Access Compliance Report

Public Rights-of-Way

(Curb Ramps)

Intersection ID: 15806	Main Street: EAST_BV	Cross Street: MARYLAND_AV	Location: SW
ADA ID: 9F58AD90DE07	Ramp Type: Directional1	Initial Pass/Fail: Fail	Overall Compliance: No
			Severity Score: 26.25

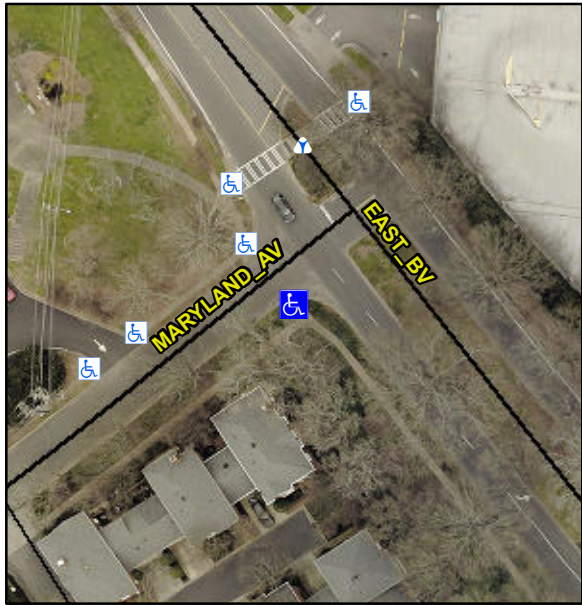
Codes/Mitigation Info/Possible Solution			Field Measurements/Component Compliance					
	Possible Solutions:		Compliance	Description	Data	Compliance	Description	Data
	Remove & Replace Entire Ramp.		N/A	Ramp Length (in)	85.0	N/A	Grade Break?	N/A
			Yes	Ramp Width (in)	69.0	N/A	Grade Break Slope (%)	0.0
			No	Ramp Slope (%)	16.3	N/A	Grade Break XSlope (%)	0.0
			No	Ramp XSlope (%)	3.7			
			N/A	Flare Type LT	N/A	N/A	Flare Type RT	N/A
			N/A	Flare Slope LT (%)	N/A	N/A	Flare Slope RT (%)	0.0
			N/A	Flare Traversable LT?	N/A	N/A	Flare Traversable RT?	N/A
	Surveyor Notes:		N/A	Landing Length (in)	0.0	N/A	DWS Provided?	N/A
	PONDING		N/A	Landing Width (in)	0.0	N/A	DWS Contrast?	N/A
			N/A	Landing Slope (%)	0.0	N/A	DWS Length (in)	N/A
			N/A	Landing X Slope (%)	0.0	N/A	DWS Full Width?	N/A
PROW/ADA:			N/A	Landing Curb? (Y/N)	N/A	N/A	DWS Offset LT (in)	N/A
R304.2.2, R304.5.3			N/A	Shared Landing?	N/A	N/A	DWS Offset RT (in)	N/A

N/A	Gutter Ponding?	0.0	N/A	Gutter Slope (%)	N/A
			N/A	Gutter Lip Ht (in)	0.0	N/A	Gutter X Slope (%)	N/A
			N/A	Painted X Walk1?	No		Road Slope (%)	3.4
				X Walk 1 Direction	To NW		Road X Slope (%)	1.3
				X Walk 1 Width (in)	N/A		Clear Space?	N/A
				X Walk 1 Slope (%)	3.4	N/A	Clear Space to XWalk (in)	N/A
				X Walk 1 X Slope (%)	1.3	N/A	Storm Grate/Utility Hazard?	N/A
			N/A	Ramp inside XWalk1?	N/A		Storm Grate/Utility Type	
			N/A	Any Obstructions?	N/A			N/A
				Obstruction Type		Yes	Surface Condition? (G/P)	Good
						N/A	Curb Slope (%)	0.5
Total Cost:		\$ 1600.00
